Re: **Okeechobee Clean Energy Center – PPSA No. PA 15-58**  
**Response to Completeness Questions and Comments**

**DISTRIBUTION LIST FOR  
FLORIDA POWER & LIGHT, INC.  
OKEECHOBEE CLEAN ENERGY CENTER**

**SITE CERTIFICATION APPLICATION**

Figure 1. Location of the OCEC Site (red square) within the domain of the ECFS groundwater model.

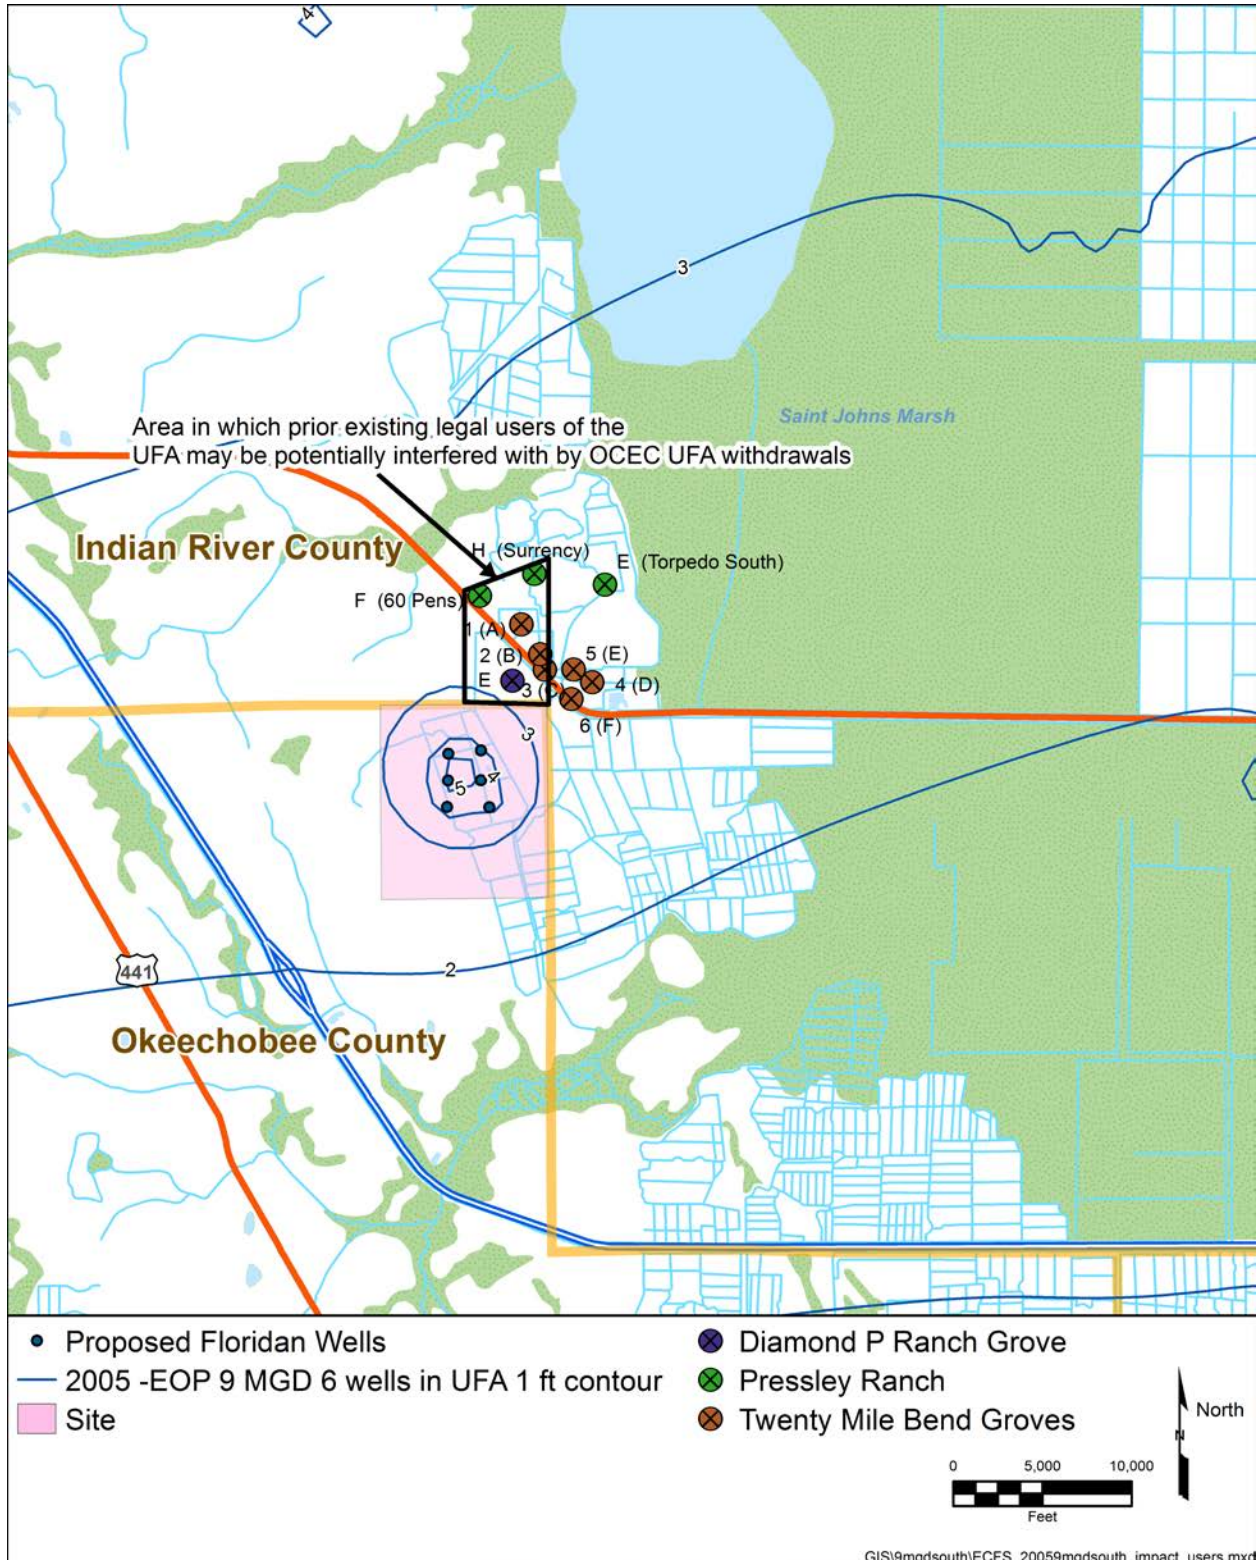
**IRC-4. Figure 1 under Appendix 10.9 should identify "Indian River County".**

**RESPONSE:** Comment noted; revised Appendix 10.9, Figure 1 is provided in Attachment IRC-4.
